NRC Public Meeting with Industry on Accident Tolerant Fuel

February 27, 2018

Draft ATF Project Plan Public Comments

Timeline and Graded Approach

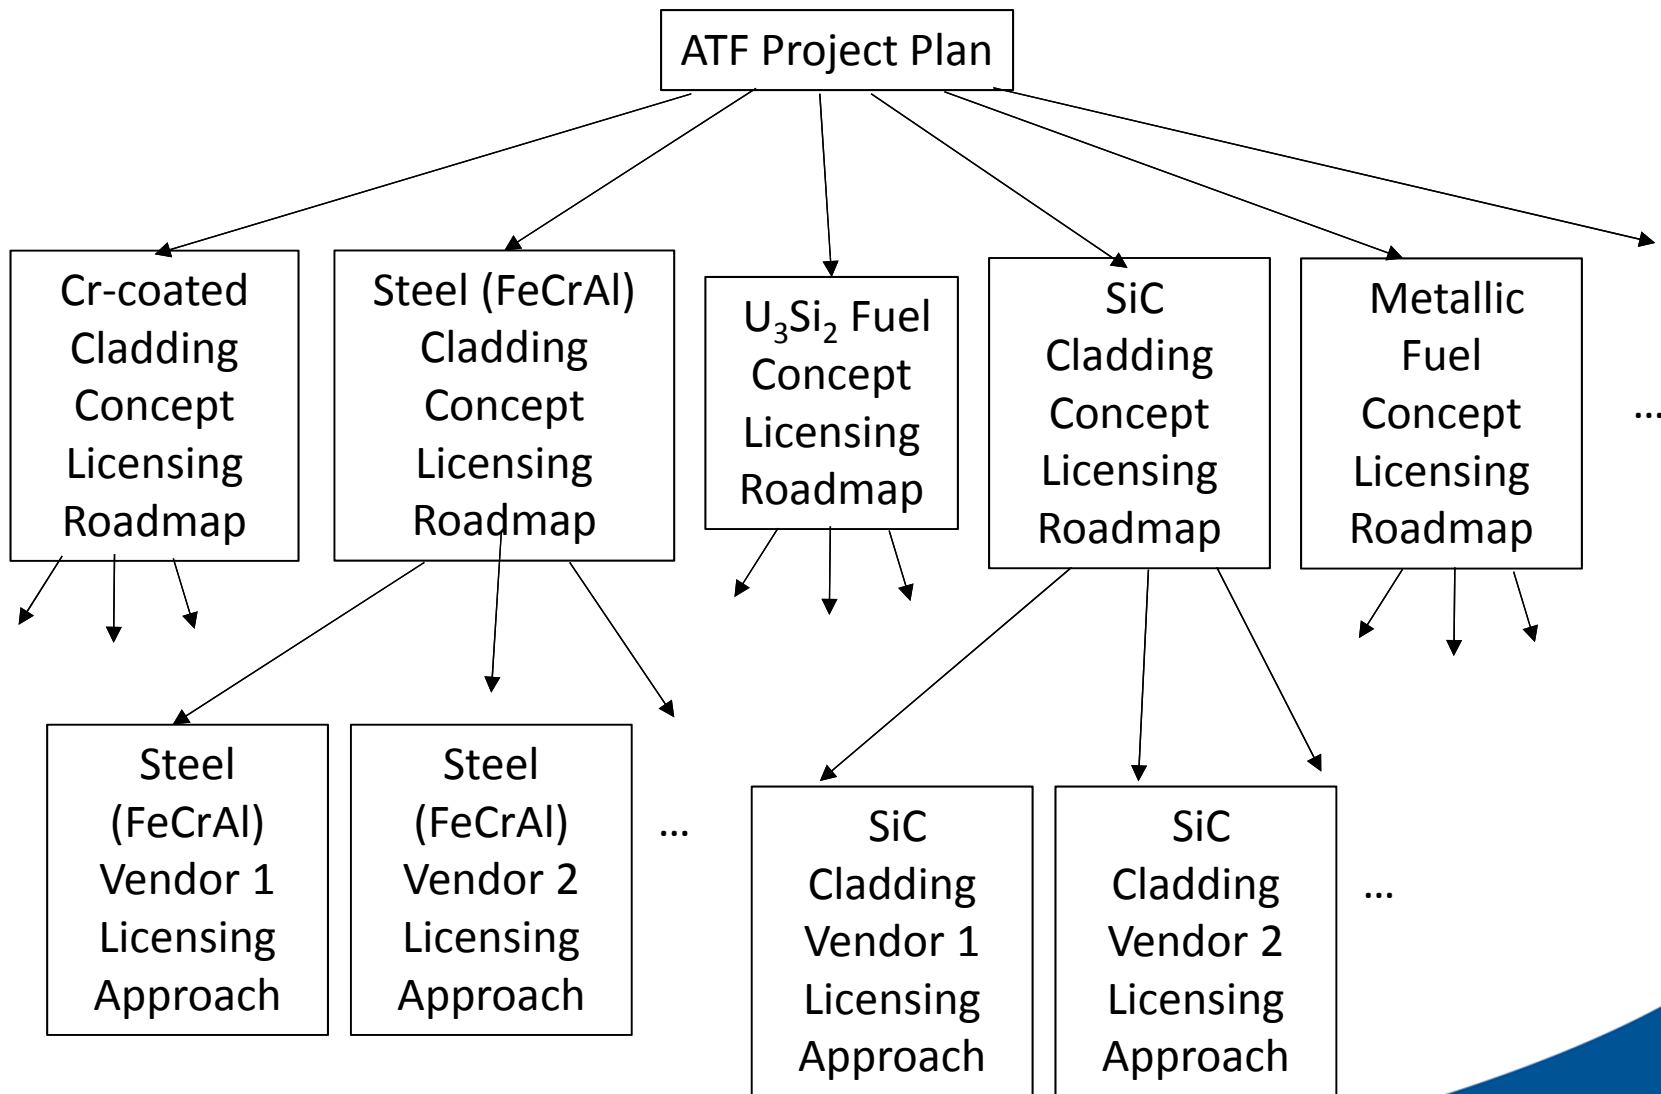
- Comment
 - Plan does not support industry's deployment schedule
 - Staff not employing a graded approach
- NRC response
 - The plan did not present a schedule but rather individual activities, many of which can proceed in parallel
 - The staff is committed to minimizing the lag between the time required to establish the technical bases for safe operation and the completion of licensing activities
 - PIRTs will inform the licensing roadmaps for individual concepts
 - PIRTs will facilitate employing a tailored approach for each concept, thus enabling a graded approach
